Change request letter

Original FCC ID: 2BNLB-BA10 ; Date of Grant: 04/11/2025

Product Name: Treadmill

Model Number: BA10

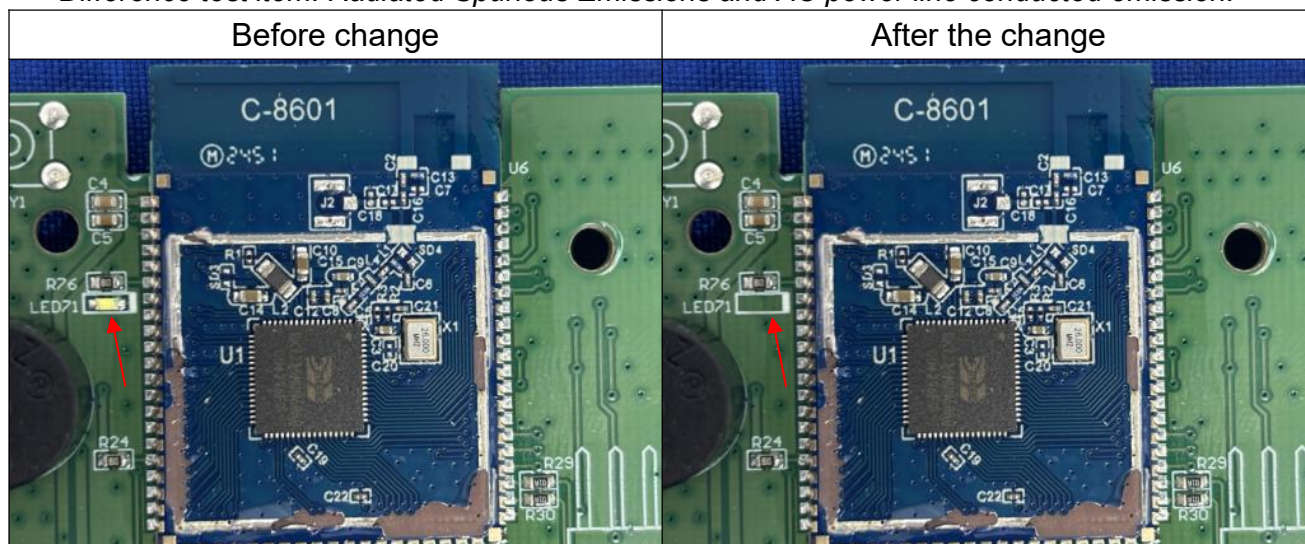
Note: According to customer's request, remove PCB Component: LED71, input ratings change:

Input: AC 120V, 60Hz, Max 1864W. Based on the original report LCSA03075057EA,
